**SWEDISH MEDICAL CENTER CHERRY HILL CAMPUS MAJOR INSTITUTIONS
 MASTER PLAN CITIZEN'S ADVISORY COMMITTEE**

Meeting Notes

Meeting #16b

June 26, 2014

Attachment #2 – Height Drawing as provided by Dylan Glosecki

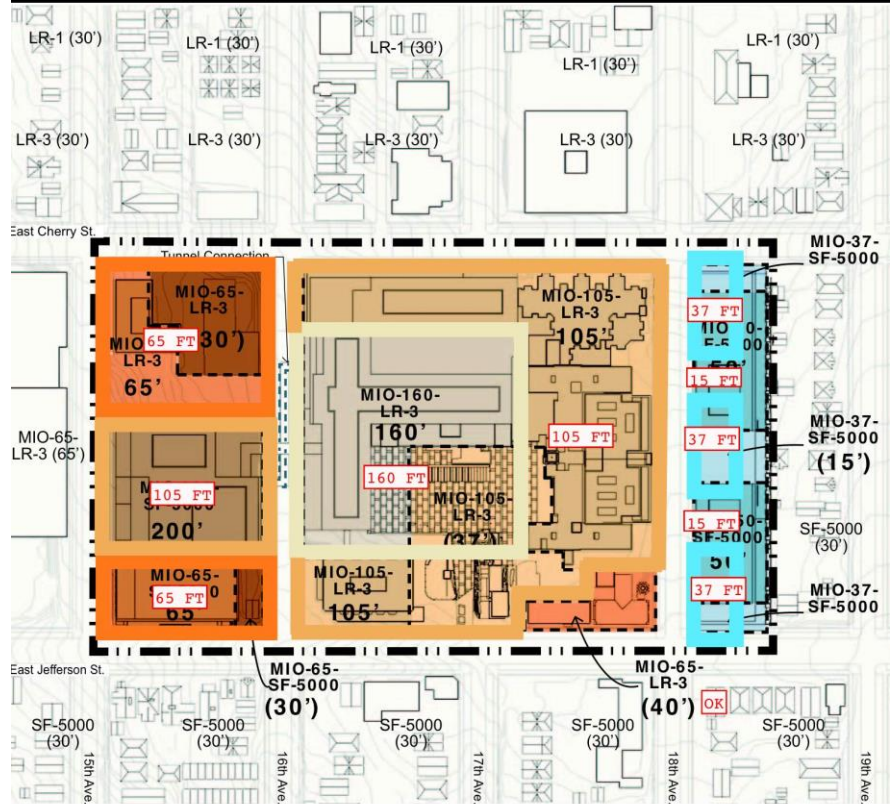
Mr. Glosecki stated that his proposal was for a heights of 65 feet those areas along East Cherry and E Jefferson Streets with 105 in the Center of the Block. Steve Shepard stated that those members who provided comments related to heights on this block for the combined document appeared split. Few appeared interested in the 200 feet proposed by Swedish in the Draft Master Plan and the Committee appeared split between 105 feet and 160 feet. He noted that it was time for the Committee to attempt to come to some consensus on this issue.

Dylan Glosecki was recognized to discuss his height proposals. He noted that he had developed them after having various conversations with neighbors and a couple of CAC members. Neighbors were clear that 105 feet was a better match to the neighborhood scale. 160 feet was considered appropriate only for the core hospital function on the central block. 200 feet was supported by no one. He therefore decided that a maximum height of 105 ft. height was most reasonable and reflected tht in his suggestions. Other's noted that there was a need for considerably more modulation of the facades on the west block.
